SUBJECT: Forwards preliminary description of Keowee Hydro Station
auxiliary load ctr transfer mod to restore automatic
transfer capability to Keowee auxiliary power sys, per 921019
loss of offsite power at Unit 2.

Subject: Oconee Nuclear Station
Docket Nos. 50-269,-270,-287
Alignment of Keowee Hydro Station Auxiliary Power

Keowee Hydro Station Auxiliary Load Center Transfer Modification Functional Description

KEOWEE AUXILIARY LOAD CENTER LOGIC DIAGRAM

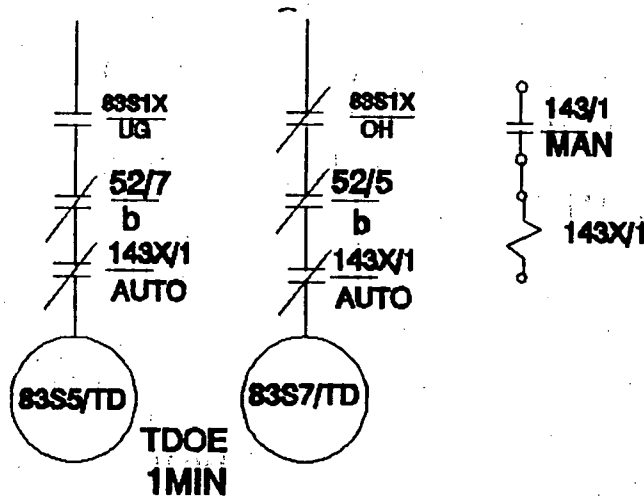
The current design has each Keowee Unit's auxiliary transformer as the normal source of auxiliary power, with transformer CX serving as a standby. This modification will change the operating alignment of the load center incoming breakers such that the Keowee Unit aligned to the underground will be normally fed from transformer CX, with that Unit's auxiliary transformer (1X or 2X) serving as the standby. The alignment will be determined by logic derived from both Keowee Unit's underground breaker position (see attached).

The modification is designed to prevent load center transfers as a result of expected transients during normal and emergency operations, and only have a load center transfer to it's backup source if the normal source is lost for one minute. This new alignment will solve the problem described in LER 269/92-19 concerning a potential fault on the 1X or 2X incoming breaker (ACB-5 or ACB-6) for the underground unit.

In addition, this modification is designed so that the load center transfer signal will originate from normal incoming breaker position versus the current design transfer only on loss of normal voltage. This will permit transfers to the standby source if the normally closed breaker trips for any reason. This provides additional defense-in-depth over the current design where a transfer would occur only if there is an undervoltage condition on the normal source.

Consistent with current design, one relay per source will be utilized. The new design will replace the four MG-6 relays in the load center transfer logic with ITE type 27N undervoltage relays. Ten Cutler-Hammer type D26 auxiliary relays will be installed; Four will be used as auxiliary relays slaved to the 27N UV relays, four will be equipped with D87 time delay-ON timer modules for the load center transfer logic scheme, and two will be used in the incoming breaker lineup logic. All new equipment will be QA qualified equipment, and will be powered from a safety related DC source. Adequacy of this design will be documented in the design input calculation for the modification.

The operation of the new transfer scheme is as follows for Keowee Unit 1 (Unit 2 is similar). Start with Unit 1 aligned to the underground --> ACB's 3 & 7 are closed. If voltage is lost from CX for more than 2 seconds, ACB-7 will trip. The 2 second time delay is long enough to avoid transient induced trips, but short enough to prevent prolonged auxiliary equipment exposure to abnormal voltage. The undervoltage relay dropout will be set to ensure adequate voltage is available to the connected loads. If voltage from CX returns within one minute, ACB-7 will re-close.

If ACB-7 does not re-close within 1 minute for any reason, and voltage is available from LX, ACB-5 will close to provide power from transformer LX. The 1 minute time delay will ensure that, without a failure, the load center will remain powered from it's normal source, and also ensure power is restored to the auxiliaries in a timely manner if a failure removes the normal source (the Keowee Units can operate for approximately 1 hour without auxiliary power).

LOAD CENTER INCOMING BREAKER LINEUP LOGIC

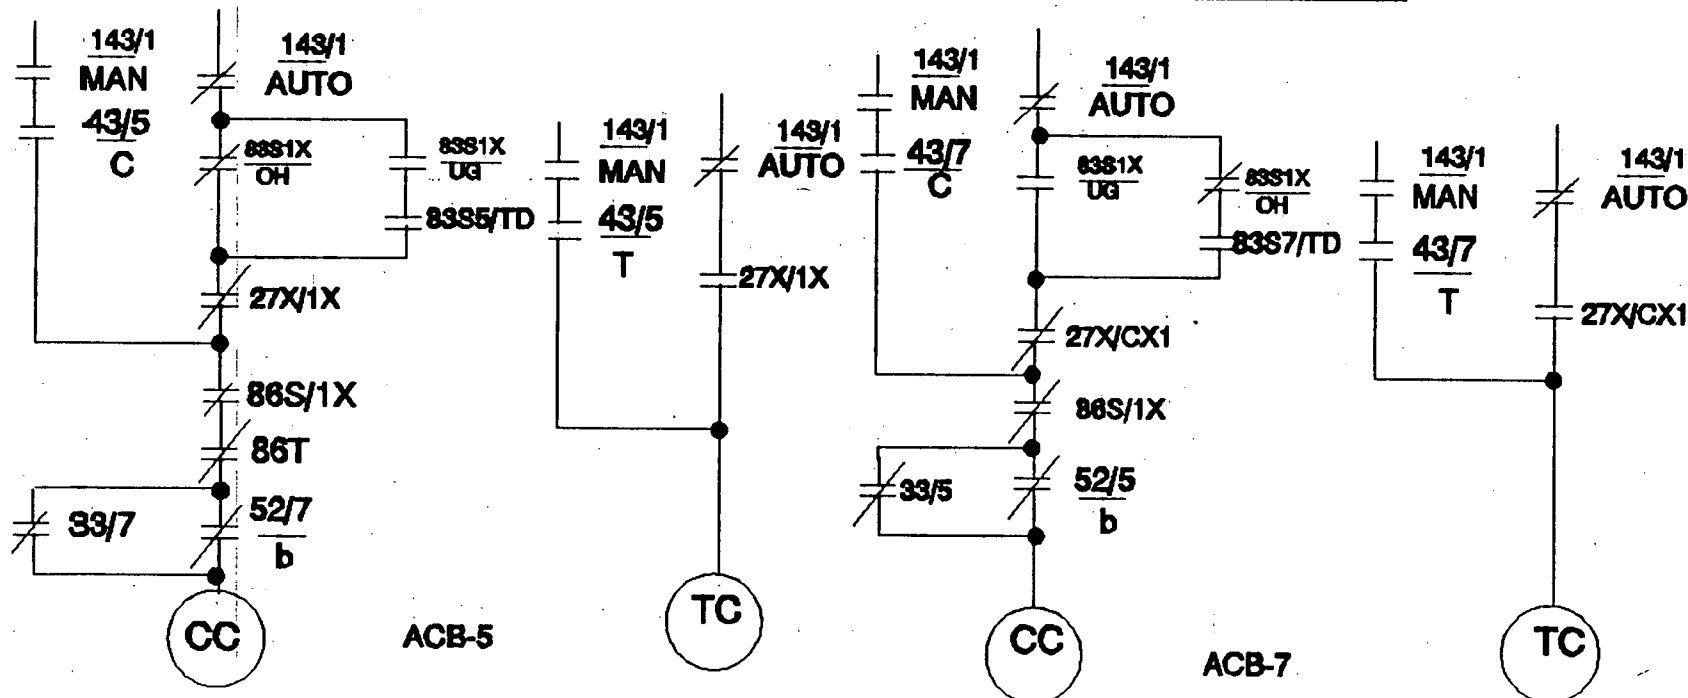
* Contacts labeled 83S1X/OH will be closed when relay is de-energized. This logic determines the normally closed load center incoming breaker.

KEOWEE ONE-LINE FOR ON-52930

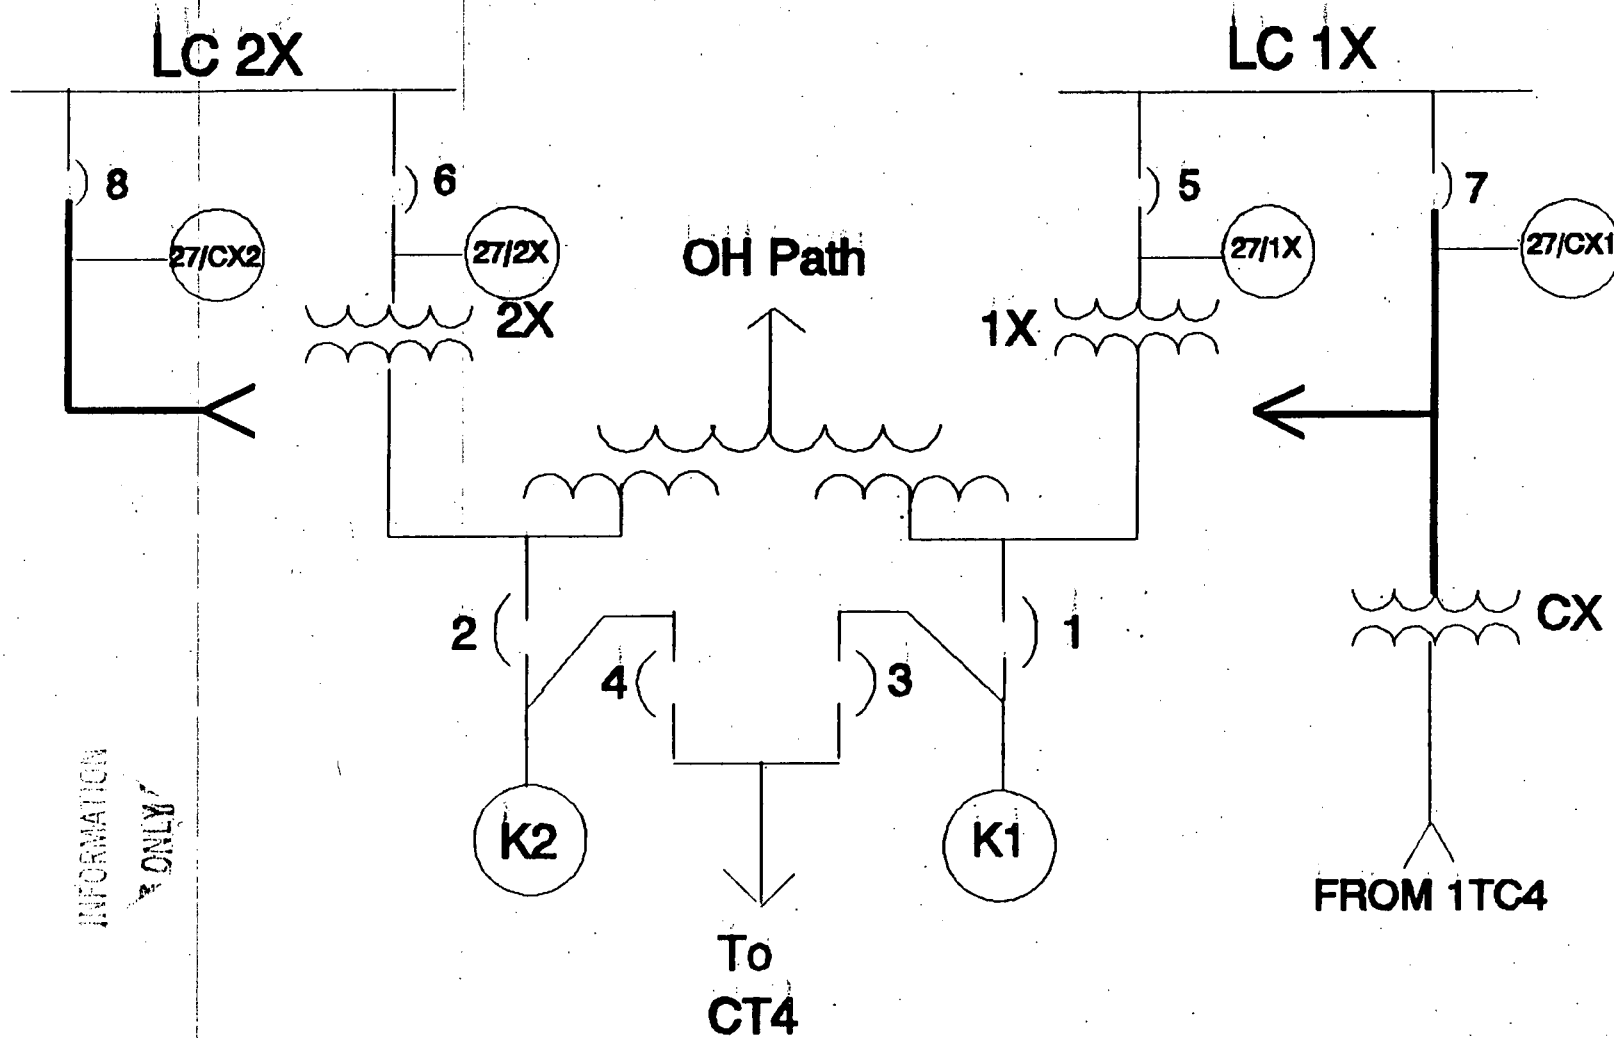
To correct design problems identified by the recently completed Keowee Single Failure analysis and the October 19, 1992 Oconee loss of power incident, the operation of the Keowee auxiliary load centers will be modified. For the following description refer to the attached Keowee One-line and logic diagram for Keowee Unit 1. Keowee Unit 2 controls will be identical.
